Kentucky Power Company  
KPSC Case No. 2022-00236  
Commission Staff's Third Set of Data Requests  
Dated November 9, 2022

**Belfry Area Improvements Project**  
 American Electric Power

**REVISED MAPBOOK SHEET INDEX**

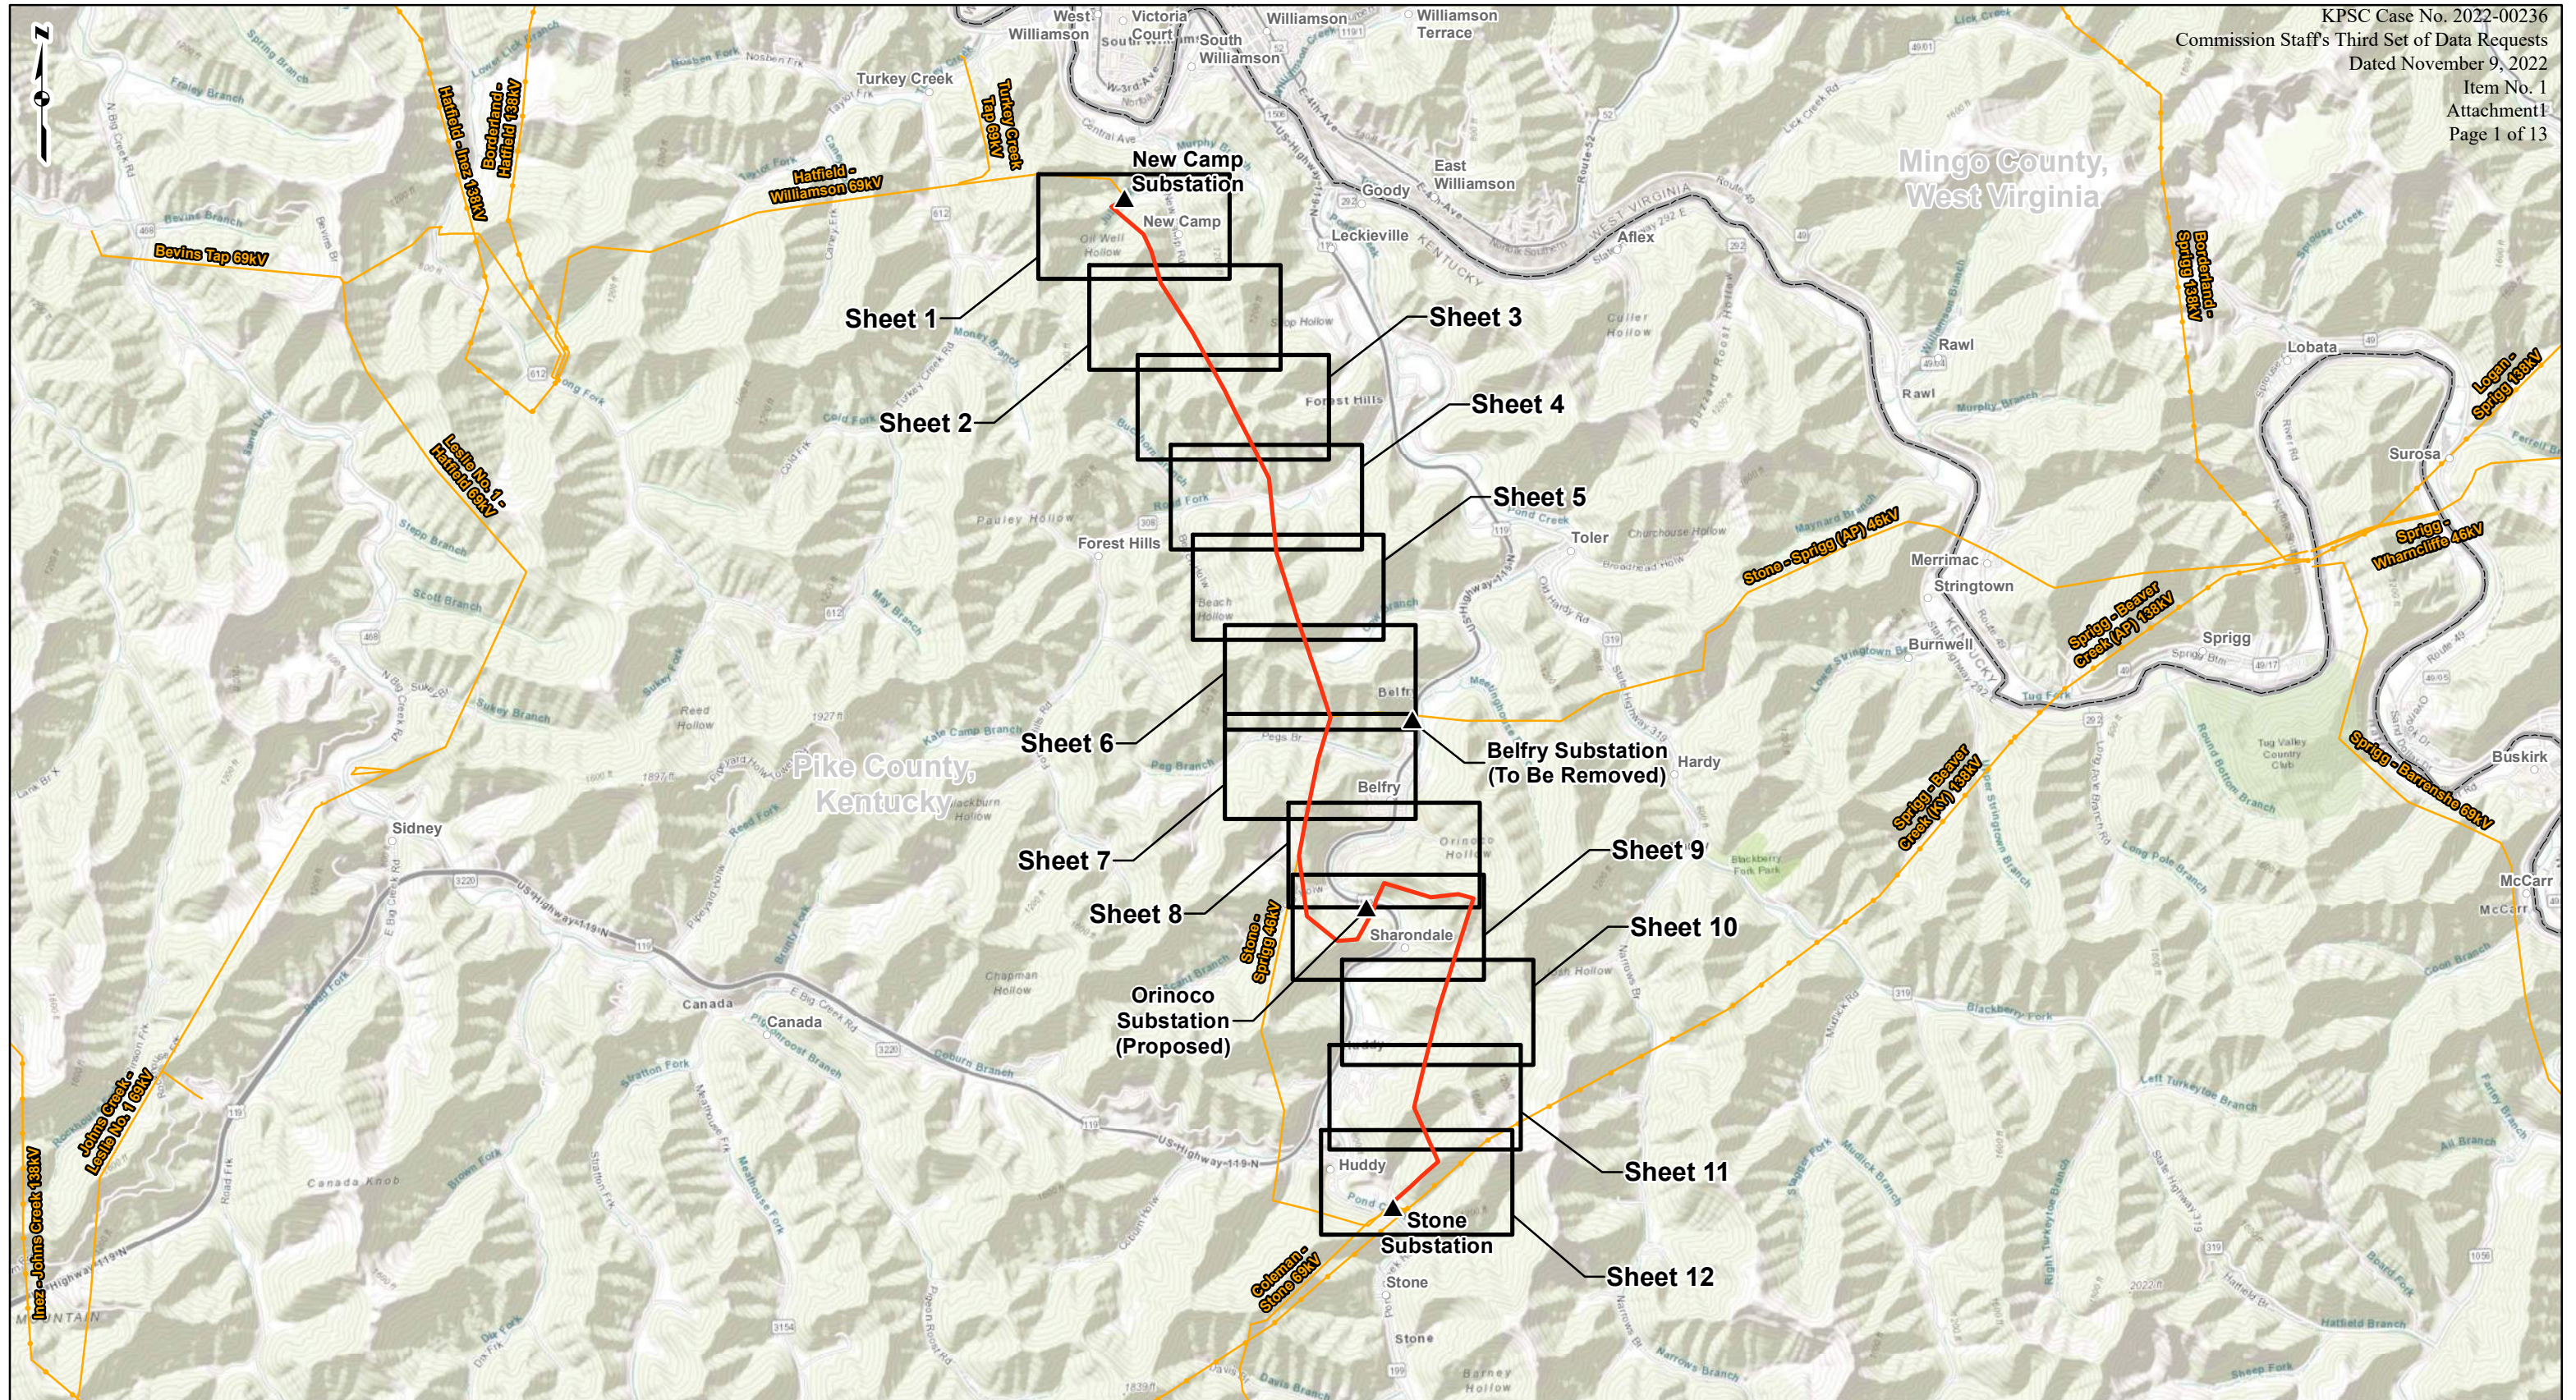
- KPSC 3\_1** Refer to Kentucky Power's response to Commission Staff's Second Request for Information (Staff's Second Request), Item 1. The topographical maps in Exhibit 4 do not provide the same level of detail as the maps in Exhibit 10.
- a. Provide the siting study map of the proposed transmission route, included on pages 81 through 92 of Exhibit 10 to the Application, with the parcel numbers from Exhibit 12 to the Application used to identify any relevant parcels shown in the siting study map and showing the location of the 400-foot Filing Area.
  - b. Explain why there are more parcels shown on the siting study map than on the map provided as Exhibit 4 to the Application.

- a. The requested mapping is provided as KPCO\_R\_KPSC\_3\_1\_Attachment1 (aerial) and KPCO\_R\_KPSC\_3\_1\_Attachment2 (topographic).
- b. The Exhibit 10 Siting Study map shows more parcels than the Exhibit 4 Proposed Route map because it includes parcels from the virtual open house. Landowners within a 1000-foot area (500 feet to either side of centerline) of all Study Segments were invited to the virtual open house. Exhibit 4 shows only those parcels on the Proposed Route that are crossed by the ROW or the 400-foot area. There were many more parcels crossed by the entire Study Segment network shown at the open house than by the final Proposed Route selected; therefore, more parcels are shown on the Siting Study map than used for the Proposed Route filing map.

**POTENTIAL ENCROACHMENT #1**

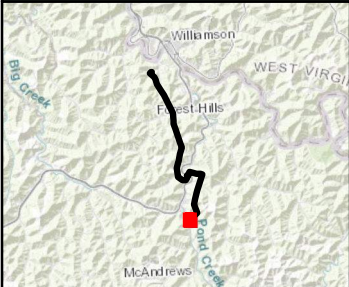
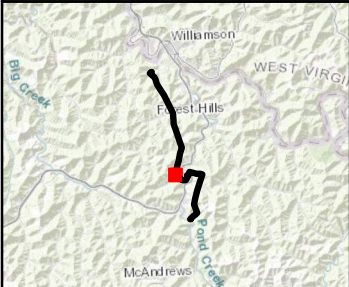
- KPSC 3\_3** Refer to Kentucky Power's response to Staff's Second Request, Item 9. For each encroachment:
- a. Provide a map(s) of the corresponding parcel depicting each building encroachment with a scale as well as measurements depicting the encroachment into the ROW and identifying the parcel using the parcel number from Exhibit 12 to the Application, if applicable.
  - b. Provide the date each encroachment was discovered.
  - c. Provide the date of the inspection, either in person or aerial, of that area prior to the encroachment being discovered.
  - d. Describe Kentucky Power's actions upon discovering the encroachment in each instance.
